Subject: SQUEAK NOISE FROM ENGINE COMPARTMENT	Bulletin No: 01-013/13
	Last Issued: 05/28/2013

- This bulletin supersedes the previous bulletin 01-021/12 issued on 07/17/12, 08/24/12 and 11/28/12. The **APPLICABLE MODEL(S)/VINS, DESCRIPTION, REPAIR PROCEDURE, PARTS, and WARRANTY INFORMATION** have been revised.
- Changes are noted below in Red beside the change bar.

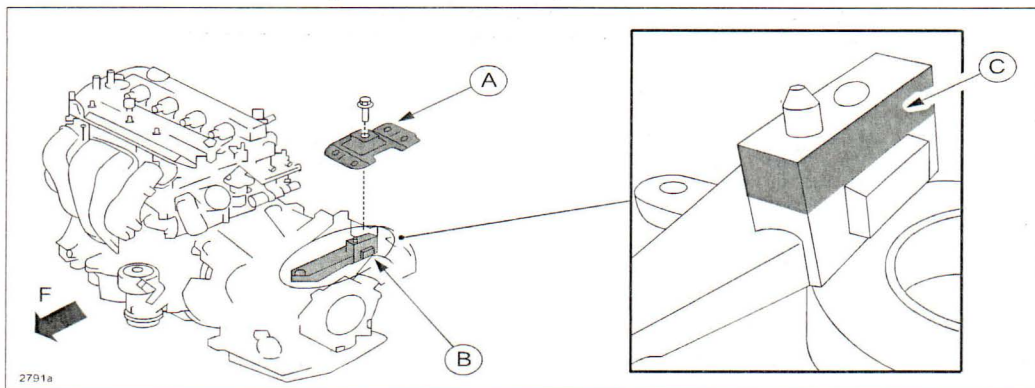
Some vehicles may exhibit a squeak noise from the engine compartment when the vehicle starts moving and/or at the time of transmission shifting. This is caused by stick-slip noise occurring at the contact surfaces between the No. 4 engine mount rubber and the No. 4 engine mount bracket when the engine shakes back and forth.

1. Verify customer concern.
2. Remove the No. 4 engine mount rubber (A) from the No. 4 engine mount bracket (B). Refer to MS3 online instructions or Workshop Manual:
 - Mazda3 SKYACTIV - (section 01-10 ENGINE REMOVAL/INSTALLATION [SKYACTIV-G 2.0]).
 - Mazda3 MZR 2.0, 2.5 - (section 01-10 ENGINE REMOVAL/INSTALLATION [MZR 2.0, MZR 2.5]).
 - **Mazda5 - (section 01-10 ENGINE REMOVAL/INSTALLATION [MZR 2.5]).**
3. Clean the surfaces of the No. 4 engine mount bracket (C) where it contacts the mount rubber.

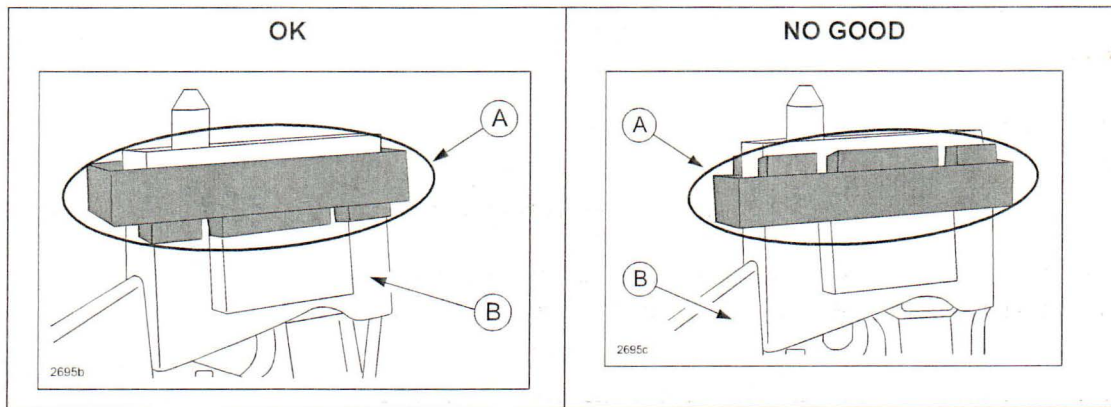
4. Install the new mount rubber (A) on the No. 4 engine mount bracket (B).

NOTE: Install the mount rubber (A) with the notched side facing down.
